# SERVICE BULLETIN

| PURPOSE : CHANGE | ISSUE NO. : MSB-14EXML34-001 | DATE : 2014-04-23 |
| SUBJECT : SHOCK ABSORBER ASSEMBLY INSTALLATION | | <DESTINATION/MODEL> (MMNA/USTP/EUR/RUSSIA /G.EXP/GCC/MMAL/NZ) OUTLANDER SPORT/ASX(GA0W) <M/Y> 13-15 |

**>>A<< SHOCK ABSORBER ASSEMBLY INSTALLATION**

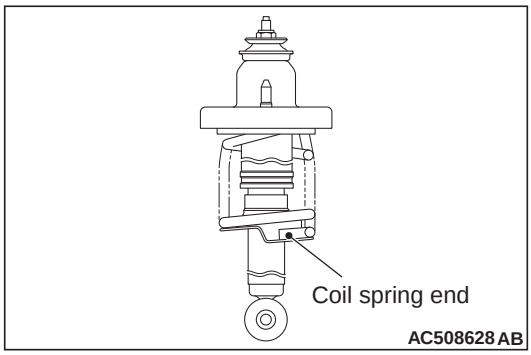
<Old> **INSTALLATION SERVICE POINT**

~~For installation service points, follow the same service procedures as 10 MY OUTLANDER.~~

**<Vehicles for Europe>**

- The procedure is the same as that for 10 MY OUTLANDER.

**<Vehicles for Russia>**

- Install the shock absorber assembly so that the coil spring end faces the rear of the vehicle.

<Old> >>A<< SHOCK ABSORBER ASSEMBLY INSTALLATION

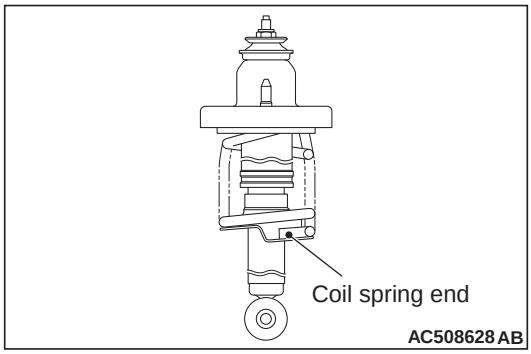
~~Install the shock absorber assembly so that the coil spring end faces the rear of the vehicle <LH>, or the coil spring end faces the front of the vehicle <RH>.~~

**<Except vehicles for General Export (MMNA production)>**

- Install the shock absorber assembly so that the coil spring end faces the rear of the vehicle <LH>, or the coil spring end faces the front of the vehicle <RH> .

**<Vehicles for General Export (MMNA production)>**

- Install the shock absorber assembly so that the coil spring end faces the rear of the vehicle.

<Old> >>A<< SHOCK ABSORBER ASSEMBLY INSTALLATION

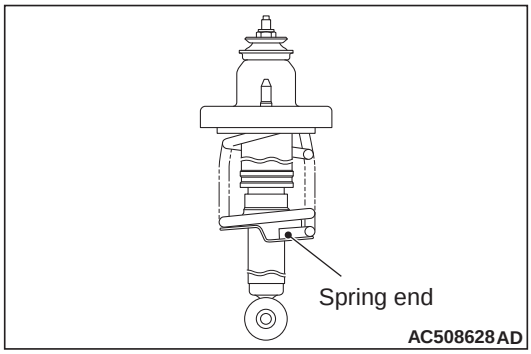
~~Install the shock absorber assembly so that the coil spring end faces the rear of the vehicle <LH>, or the coil spring end faces the front of the vehicle <RH>.~~

Install the shock absorber assembly so that the coil spring end faces the rear of the vehicle.
